TITLE: *UDOGM State Decision Document and Technical Analysis
- Response to Board's Order - Updated January 9, 2002*

UTAH DIVISION OF OIL, GAS AND MINING
STATE DECISION DOCUMENT AND
TECHNICAL ANALYSIS

RESPONSE TO BOARD ORDER

UtahAmerican Energy, Inc.
HORSE CANYON MINE
Lila Canyon **Revision** **Extension**
C/007/013

Figure 1. Figure 1. Illustration of coal zone, Sunnyside member (Kbs), and undifferentiated Flagstaff Limestone and North Horn Formation (TKfn) aquatard which separates the coal zone from Range Creek.

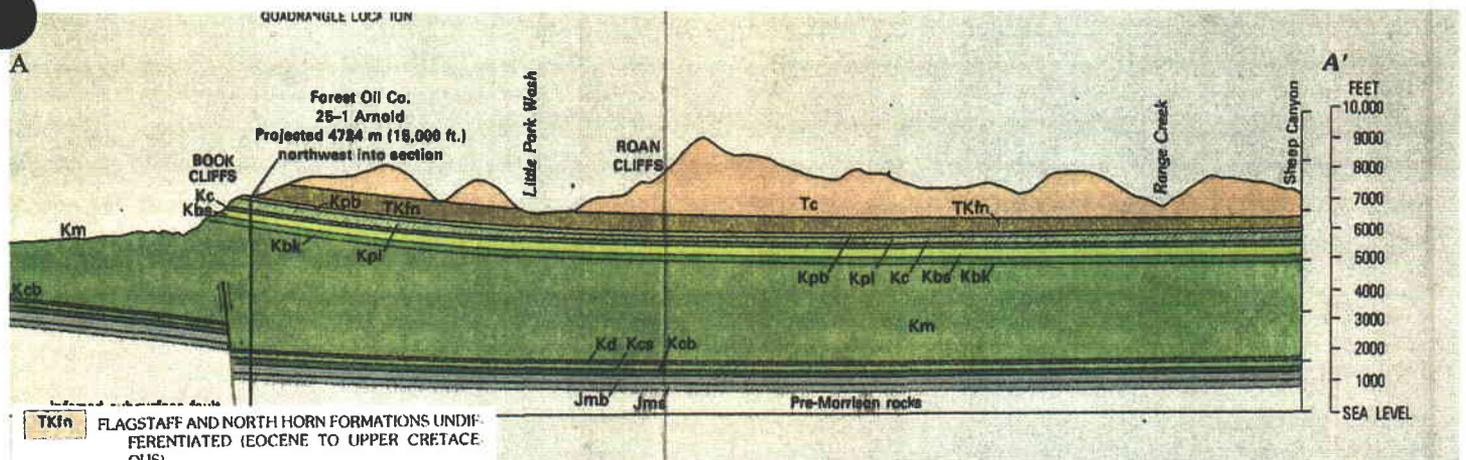
elevation of Range Creek increases rapidly. At the nearest poing, 4 and one-half miles northeast of IPA-1, Range Creek is 600 feet higher than the water in the piezometer (see figure 1 at the end of the document). The Division also considered the thick section, 1000 feet or more, of low-permeability strata between the Blackhawk and the Colton Formations (Section 724.200).

Creek in any way. Aquifers in the Colton Formation and undifferentiated North Horn- Flagstaff formations will not be impacted because the amount of strata between these aquifers and the coal seam, the aquitard characteristics of these strata and the capacity of these strata to seal fractures and faults will restrict vertical movement of water. Also, the undifferentiated North Horn-Flagstaff formations and Mesa Verde Group have low hydraulic conductivity and will prevent the vertical movement of water from the deep zone upward to Range Creek. Groundwater would have to travel a great distance through very low permeability rock to reach Range Creek as shown in Figure 1 (attached).

Figure 12. A cross-section of the Book Cliffs showing the relationship between mining, geologic strata and ground water before and after mining.

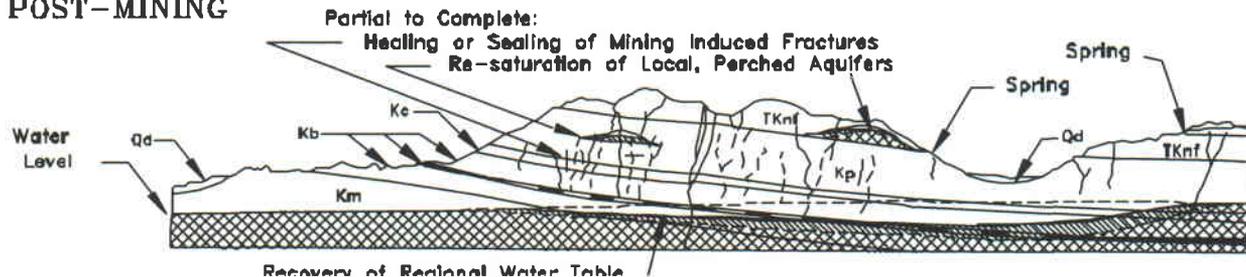
similar to those observed in the Soldier and Horse Canyon Mines. Most water entering mines comes from ground water stored in the overlying strata after fracturing of the rock above the mine. Due to the great amount of strata between the Lila Canyon Extension Mine and springs on the surface, the springs or their recharge sources will not be affected. The mobility and expanding characteristics of clays, shales and mudstones in the overlying strata should also help seal conduits created by fracturing (Figure 12).
